MATERIALS LICENSE

License Number
29-00139-02

RESPONSE TO NRC REQUEST FOR ADDITIONAL INFORMATION - LICENSE #29-00139-02

DR.: R. G.	E. R. SQUIBB & SONS, INC.				C.A.R.	
DATE: 9-27-68	NEW BRUNSWICK N. J.				P. N. 124-196	
SCALE: N.T.S.	MODIFICATION TO STACK SAMPLING SYS.				D. N.	
OR					DRAWING NUMBER	
APPD	NO.	REVISION	DATE	BY	APPD	SK 9907
APPD						
APPD						
APPD

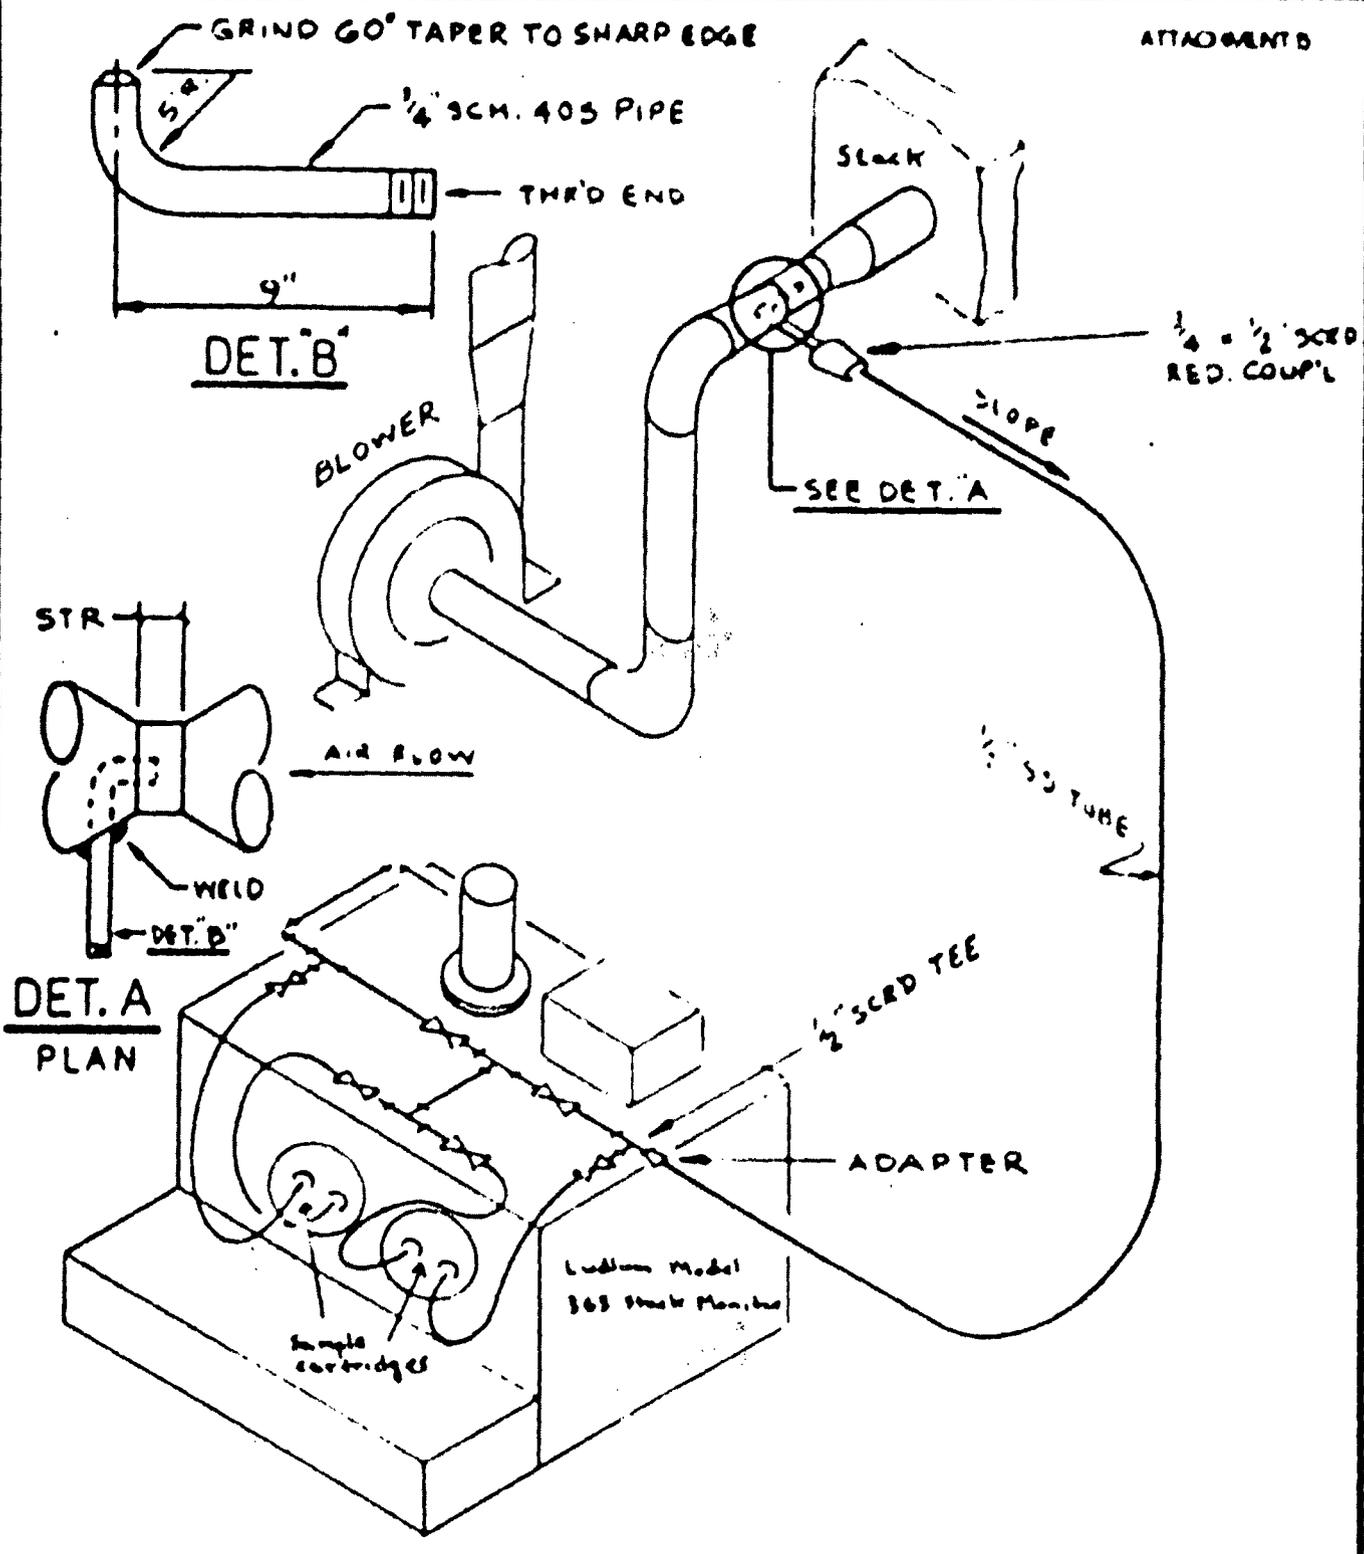
Provide a schematic diagram of all effluent pathways at each site which includes the identification of the source of the activity, the maximum typical activity at each source, the location of the sampling points in each ventilation pathway, and each contributing and final ventilation flowrates for each pathway.

Provide a schematic drawing showing the location of the sample cartridge and the stack alarm detector. Paragraph #5 on page 1-8 states: "The radioactivity in the sampler is constantly measured by the stack alarm detector which will sound an alarm in the Health Physics operations area should the integrated activity representing the 24 hour effluent limit for I-131 as specified in Appendix B, Table II, Column I of 10 CFR 20 be exceeded." Provide specific details about the stack alarm detector, and specify whether the alarm setpoint(s) interact with the HVAC system.

All ventilation systems in the manufacturing area are manifolded to a single stack prior to release to the environment. Page 15, paragraph 5 of the February 18, 1997 license renewal application details the sampling of this effluent pathway. The typical flowrate through this stack is approximately 70,000 cfm, seven days a week, twenty-four hours per day. The primary contribution to the effluent is due to hot cell operations where approximately 35 Curies per week of ^{137}Cs is processed. Each ventilation pathway is monitored by pre and post air sampling tubes as described in Question 2.a above. A schematic of the Building 124 ventilation system is attached (see Attachments 1 & 2).
